### **ADDENDUM TO:**

Determination of Nonsignificance (DNS), Parcel 14 Grading and Habitat Restoration Projects, Issued 1/3/2013, by the Port of Tacoma; and the associated Environmental Checklist, submitted 1/2/2013 by the Port of Tacoma.

### **PARCEL 14 HABITAT AND GRADING PROJECTS**

# DRAINAGE DISTRICT 23 DITCH ALTERATIONS

DATE: 12-6-12  
 REVISED 2-18-2015  
 SHEET: 2 OF 14

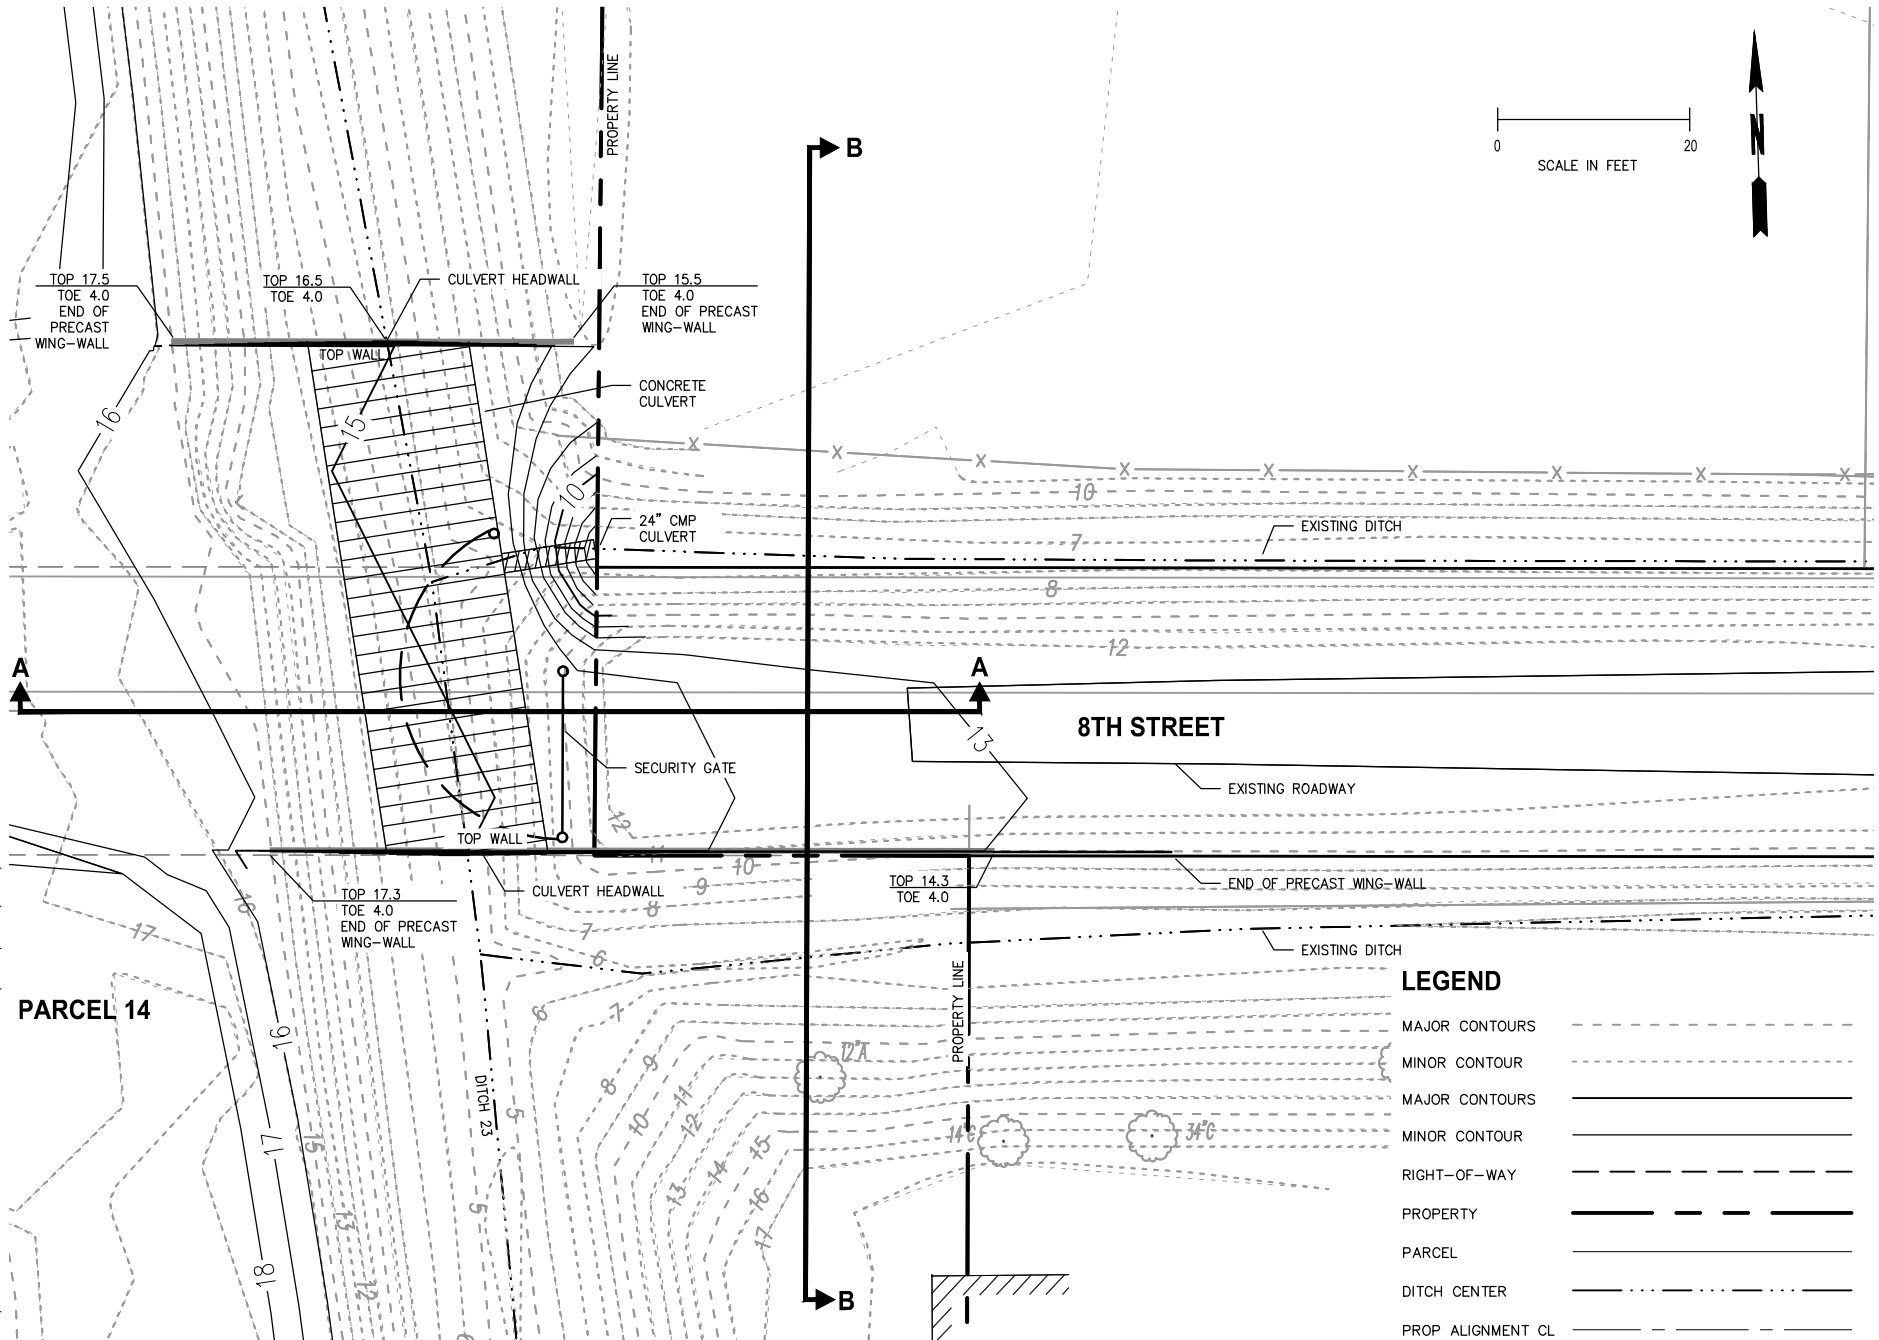
The on-site grading contours for the Grading Project have been revised as shown on the revised Grading Project SEPA plans (attached) to update the drainage contours to reflect a preload stockpiling of the excess site soils and duff material as an alternative option. The work described in the original proposal to export soil/duff material from the site may still occur, but it may be after the preload stockpiles have been created.

DATE: 12-6-12  
 REVISED 2-18-2015  
 SHEET: 4 OF 14

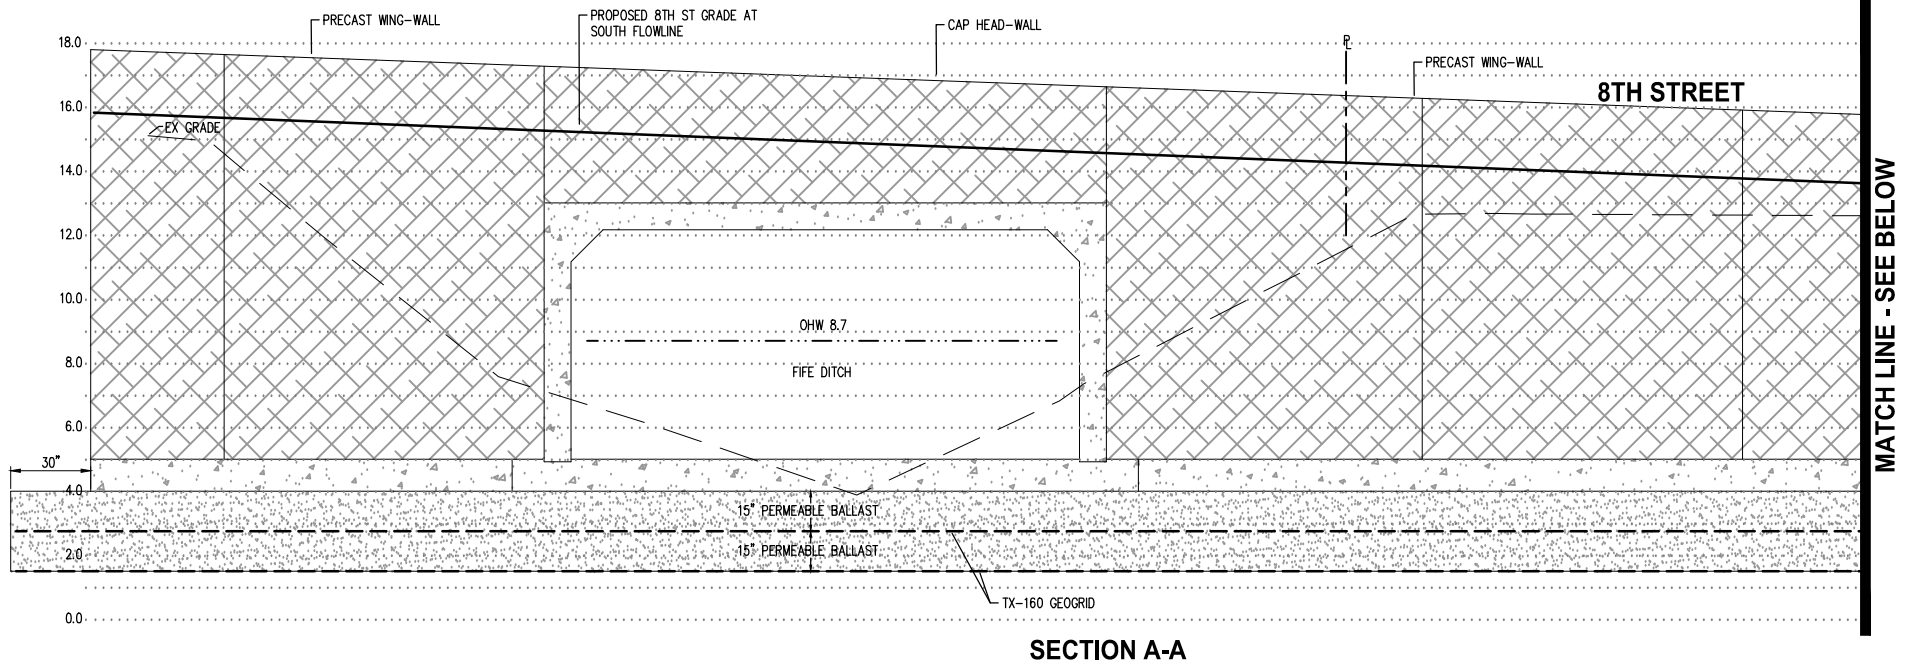
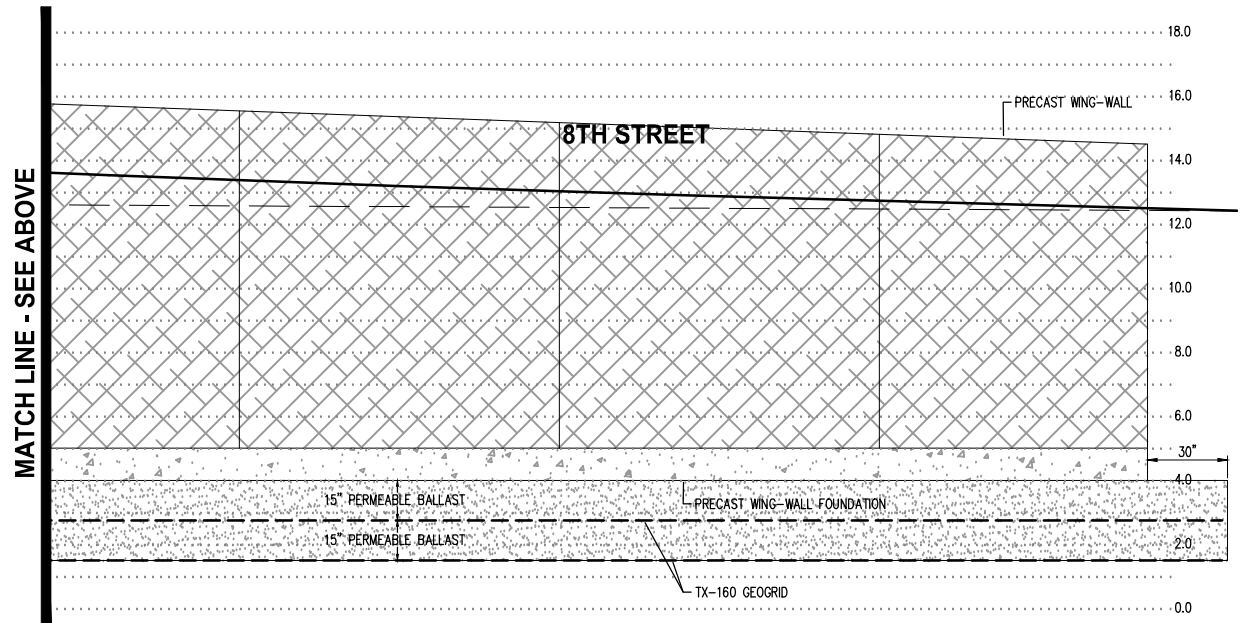
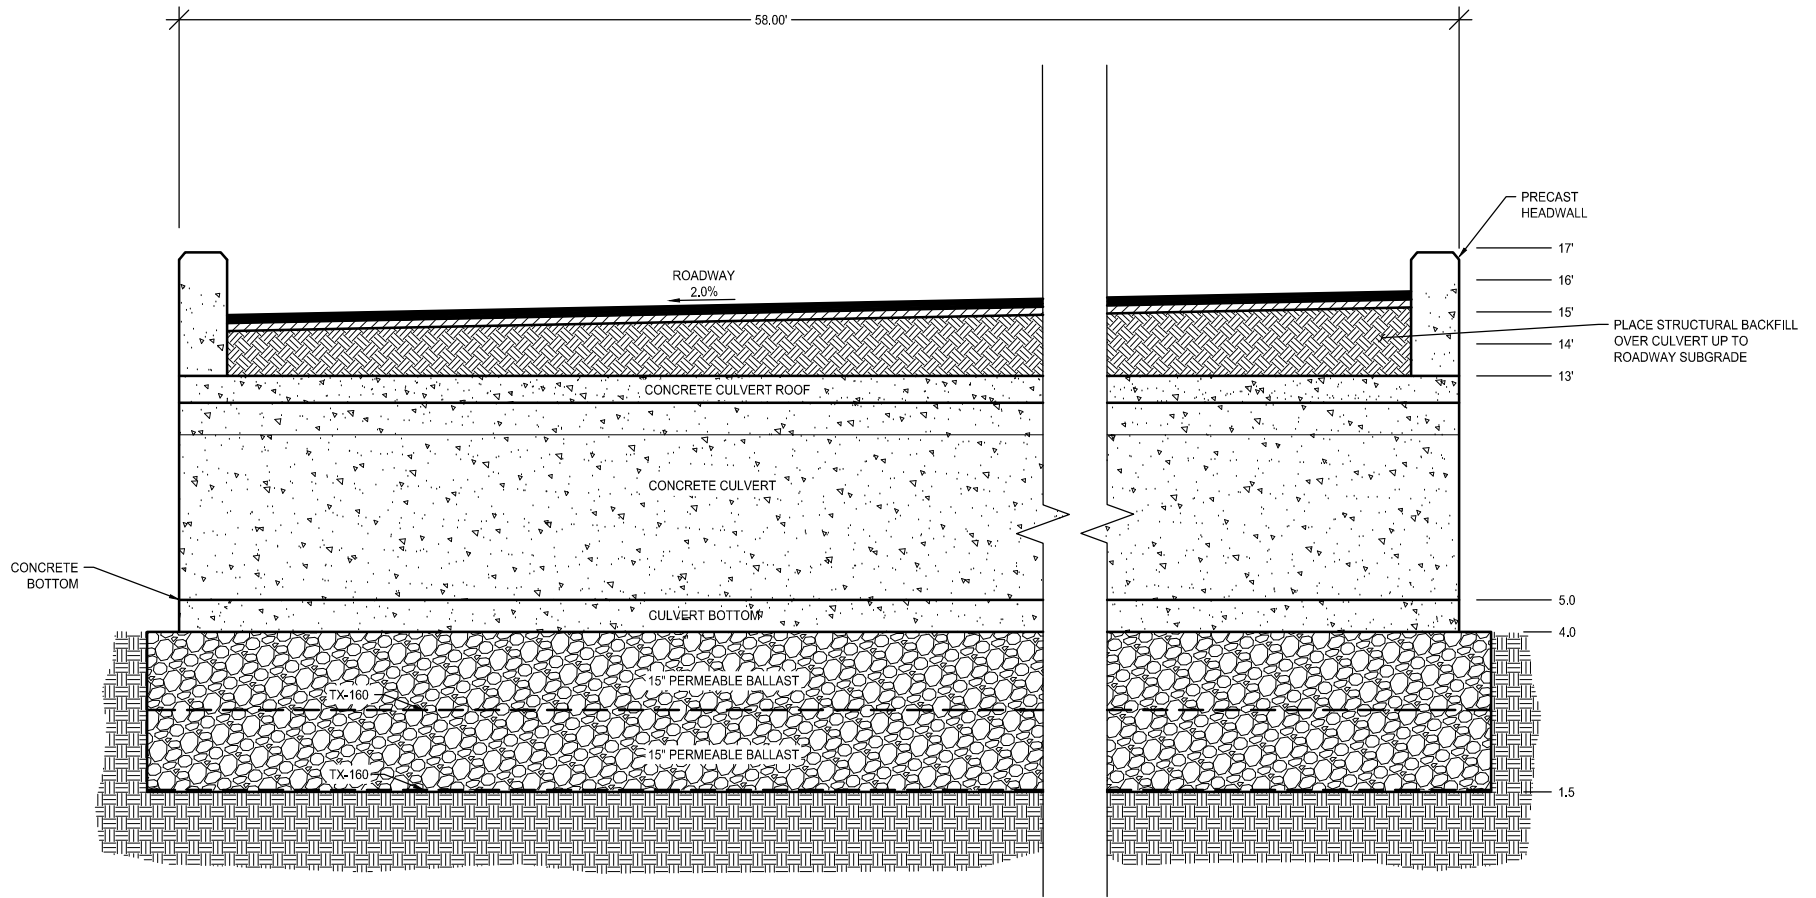
The 8<sup>th</sup> Street E entrance may be constructed utilizing a concrete box culvert as shown on the revised Grading Project SEPA plans (attached) instead of the metal arch culvert that was originally proposed. The box culvert will be within the same footprint of the metal arch culvert and will not substantially change the fill quantities proposed under the arch culvert design.

Changing the 8th Street E culvert from a metal arch culvert to a concrete box culvert will not substantially change the fill quantities proposed under the arch culvert design as both culverts are within the same footprint.

DATE: 12-6-12  
 REVISED 2-18-2015  
 SHEET: 8 OF 14

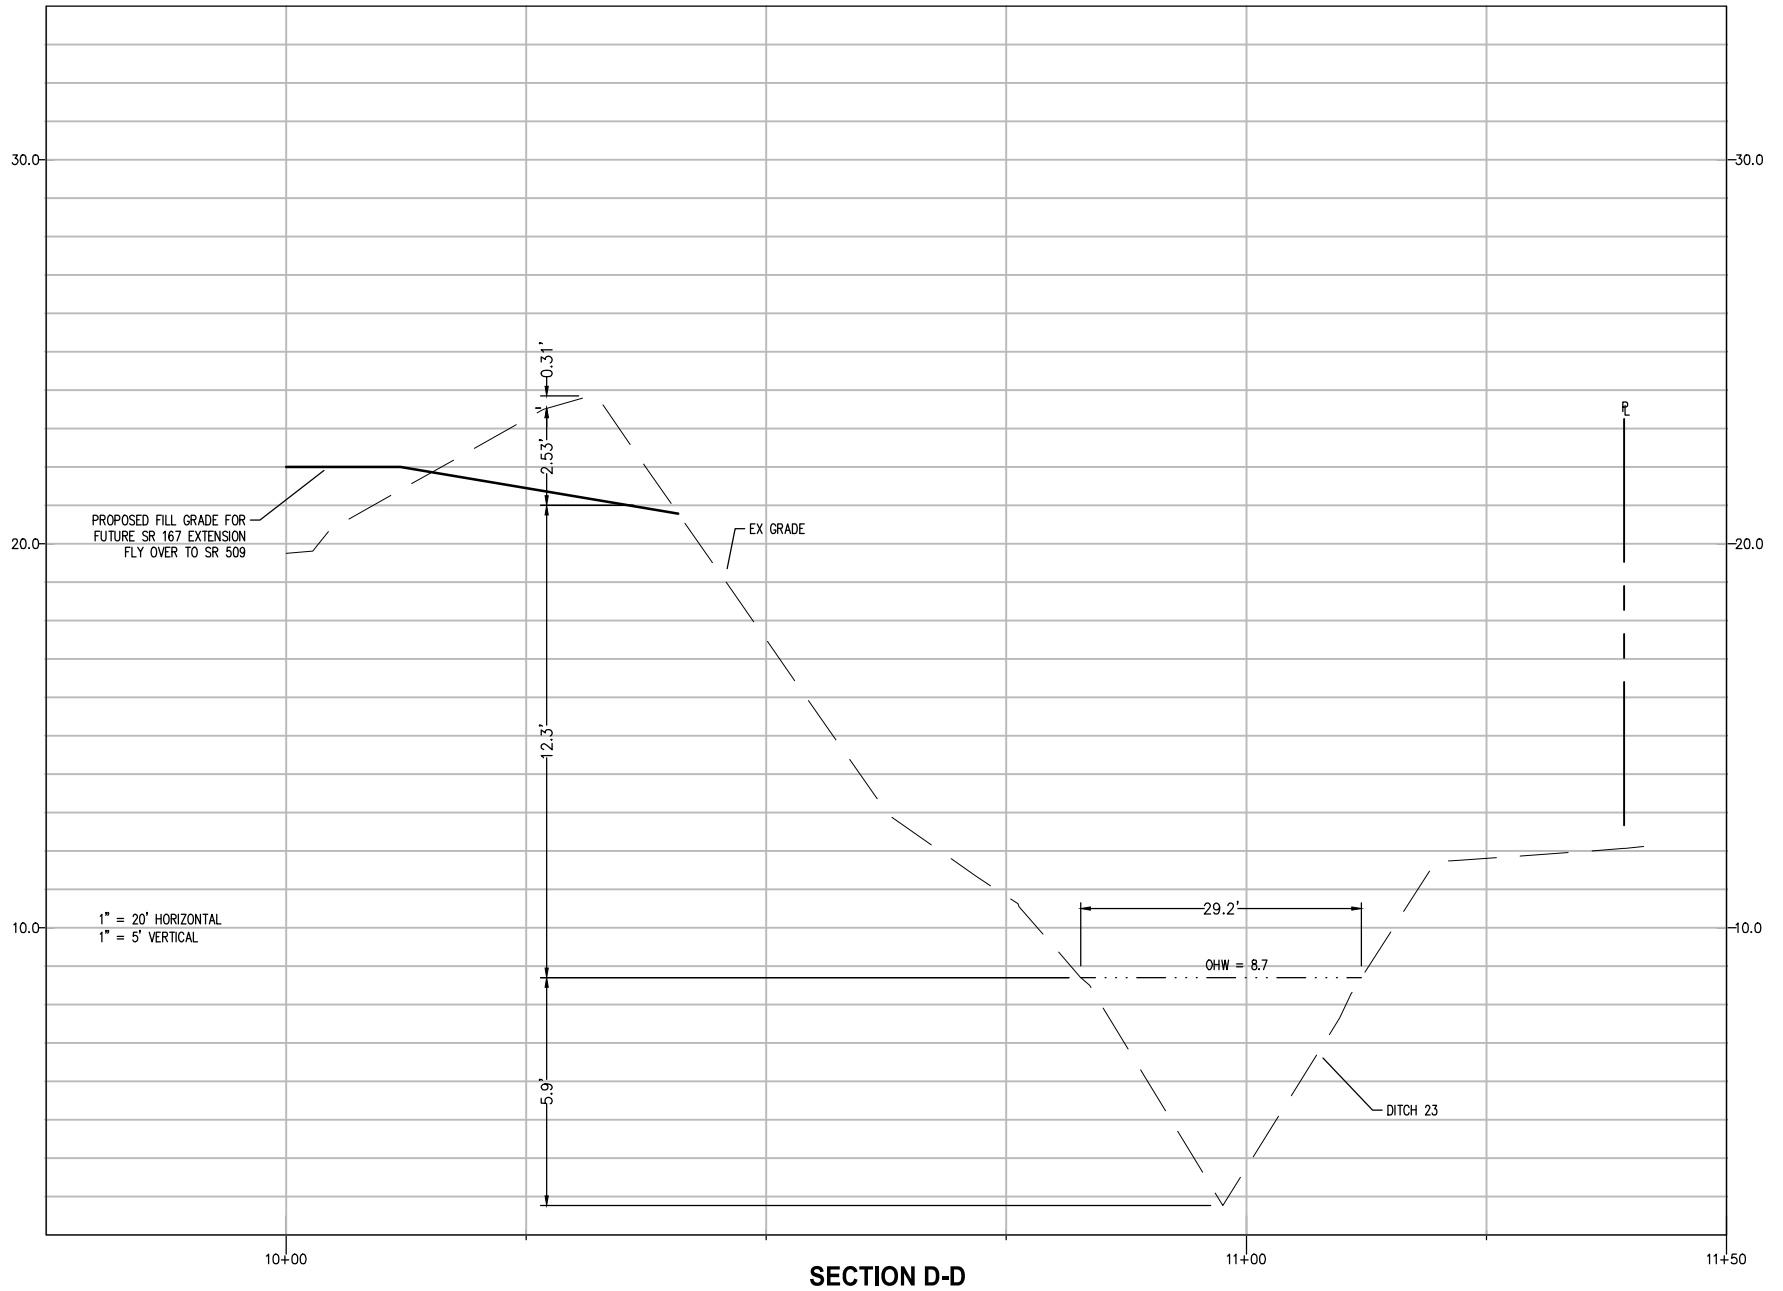
The stormwater storage basin was modified during final design as shown on the revised Grading Project SEPA plans (attached) to leave a narrow berm along a portion of the Drainage District 23 Ditch in order to maintain the flow pattern in the ditch and prevent erosion of the stormwater storage basin after construction.

DATE: 12-6-12  
REVISED 2-18-15  
SHEET: 13 OF 14

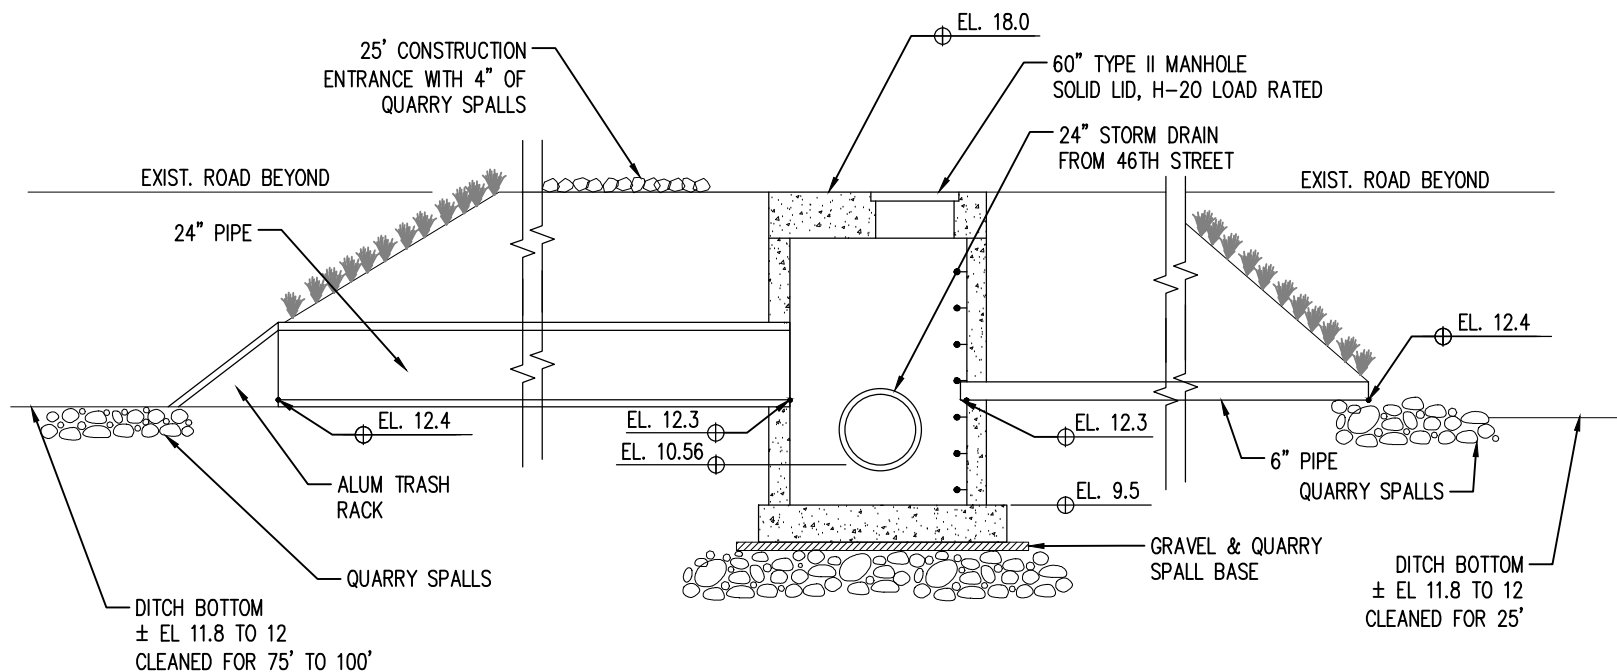
- A 12<sup>th</sup> Street E entrance will be constructed at the intersection of 46<sup>th</sup> Avenue E as part of the Grading Project. The SEPA plans originally contemplated constructing this entrance over a portion of the Fife Ditch (along 12<sup>th</sup> Street E) that was going to be filled as part of the Habitat Restoration Project. As construction for the Grading Project has proceeded independent of the Habitat Restoration Project, and because a City of Fife outfall was discovered in this area, the entrance was re-designed to be constructed using a culvert and manhole to maintain the drainage function of the Fife Ditch and the City of Fife outfall. Once installed, this entrance is anticipated to be the primary entrance for construction workers (small vehicles) to access a nearby staging/laydown area. It may be necessary to use this entrance for some equipment delivery/removal or trucking; however, the 8<sup>th</sup> Street E entrance will be utilized primarily for this type of access to the extent practicable. This new entrance will remain for access to the site after completion of the construction projects.

In order to accommodate the entrance and daylight a plugged City of Fife 24" concrete storm drain outfall, a new 60" diameter Type II Manhole will be installed in the ditch with a bottom elevation of 9.5' and a rim elevation of 18'. The manhole will be placed on several inches of gravel (1 CY) over a minimum of 2' of quarry spalls (4 CYs) to provide a stable base for the manhole to sit on. The existing 24" City of Fife storm drain will be extended 6 LF into the new manhole with an invert elevation of 10.56'. A new 6" PVC pipe, 32' long will be installed from the manhole to the remaining ditch west of the construction entrance. This 6" PVC pipe will have an invert in the ditch of 12.4' and in the manhole of 12.3'. Approximately 1 CY of quarry spalls will be placed at the inlet of the 6" PVC pipe at the bottom of the ditch. This pipe will be located approximately 0.4' above the bottom of the ditch to prevent water from the manhole spilling into the ditch. This pipe is relatively small due to the insignificant amount of drainage required from the ditch section west of the new entrance, which is planned to be filled as part of the Habitat Restoration Project.

A new 24" drain pipe (PVC or ABS), 56' long will be installed from the manhole east into the ditch. It will have an invert elevation in the manhole of 12.3' and an invert elevation at the ditch of 12.0'. An aluminum trash rack will be installed on this pipe at the outlet and approximately 1 CY of quarry spalls will be installed at the outlet location to prevent erosion.

The construction entrance is approximately 60' wide (east to west) and 34' long (north to south) at the ditch. The sides of the entrance will slope into the ditch at a 4:1 slope. Approximately 295 CY of fill material (gravel and quarry spalls) will be placed in the ditch to create the base and wearing course for the entrance. This ditch does not usually hold water and typically is dry except during rain events when the water flows east to the Drainage District 23 ditch. The side slopes will be hydroseeded and the wearing surface will remain quarry spalls or gravel as required for the construction entrance BMP per the Department of Ecology requirements.
